231st Meeting of the Machine Protection Panel

November 25th, 2022, via Zoom

Hardware transmission of DC-BCT intensity to SMP SPS and LHC (T. Levens)

Figure 1 SPS BCT / SMP architecture schematics.

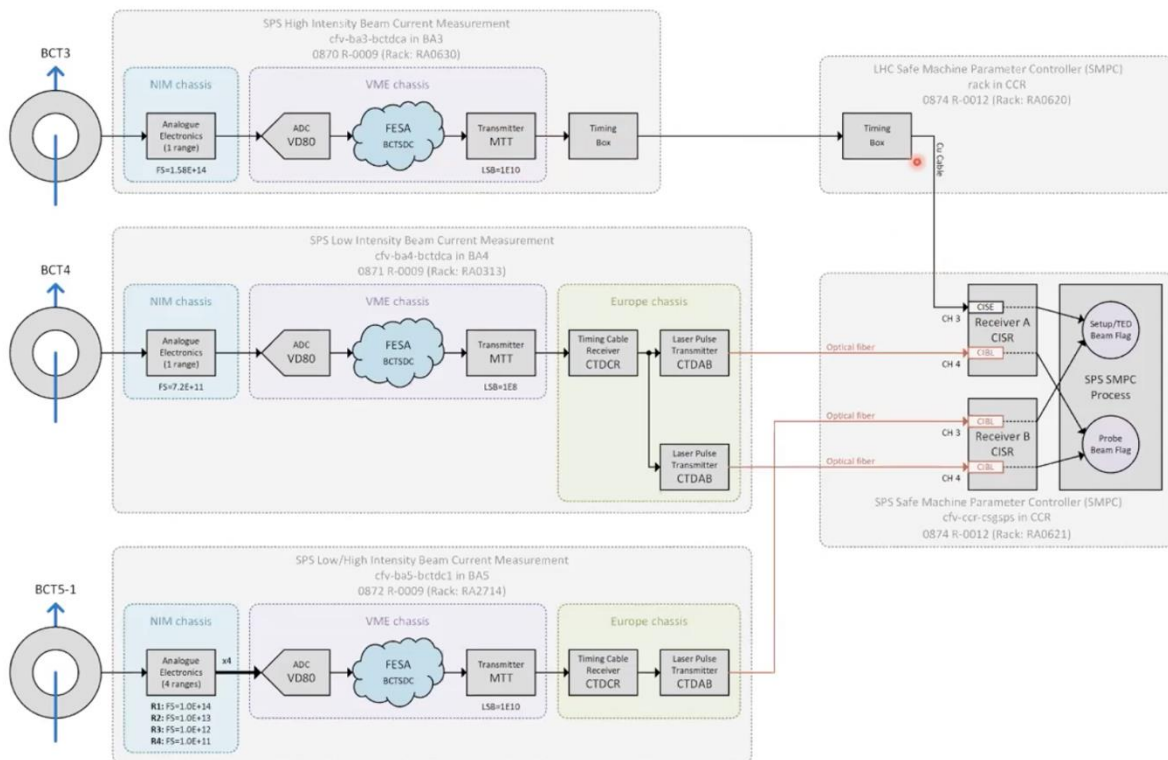
The proposal is to keep BCT3 and BCT4 as they are. BCT3 will provide the high intensity channel 3A and BCT4 the low intensity channel 4A. The BCT5 connection will be modified to send SMP directly from VFC-HD. The range 1 will feed the high intensity channel 3B and the range 3 channel will feed the low intensity channel 4B. This requires modifications on the SMP side (see next presentation of this meeting). BCT 5, thus, provides diverse redundancy.

Jan commented on the long history of the issue and thanked the team for improving the system. Jan asked which option should be chosen for the LHC. Tom replied that he proposes to use the direct connection with the VFC. Jan commented that then we should do that from the start. Daniel agreed.

Daniel asked why the same solution is not chosen for the B channel. Tom replied that the B channel is still on the 16-bit acquisition system.

Daniel added that the proposal should be written in a ECR.

Action: Draft ECR on the proposed DC-BCT and SMP changes for the SPS (T. Leven, R. Secondo).
